Product Change Notice (PCN)

PCN Number: **PCN-053-9036R-01**

Product(s) Affected: **CBL-UC-UC-1**

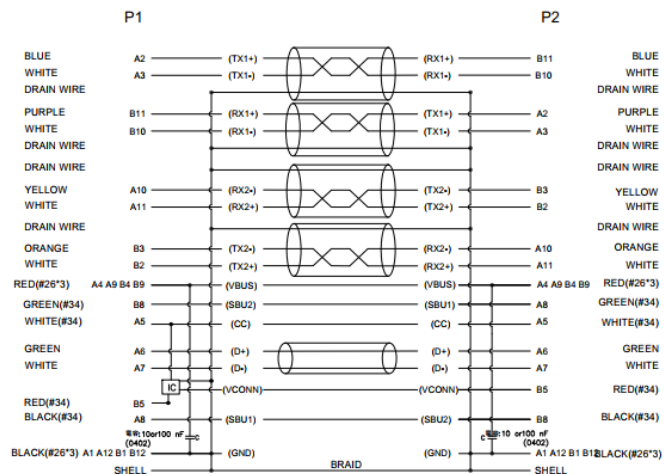
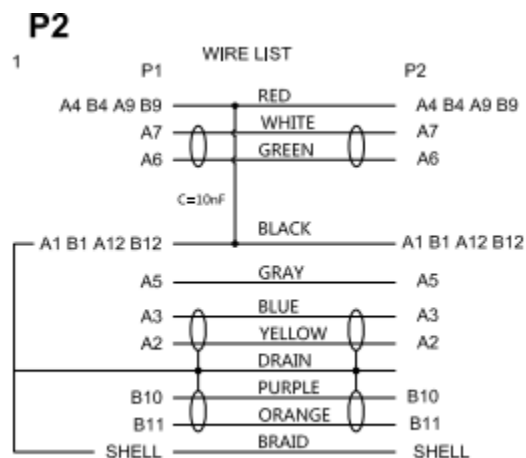
Description of Change: **Wiring Pinout configuration change. IC chip added to VCONN connection.**

Product Availability: **Any production orders marked June 24, 2024, or later will have the new design implemented.**
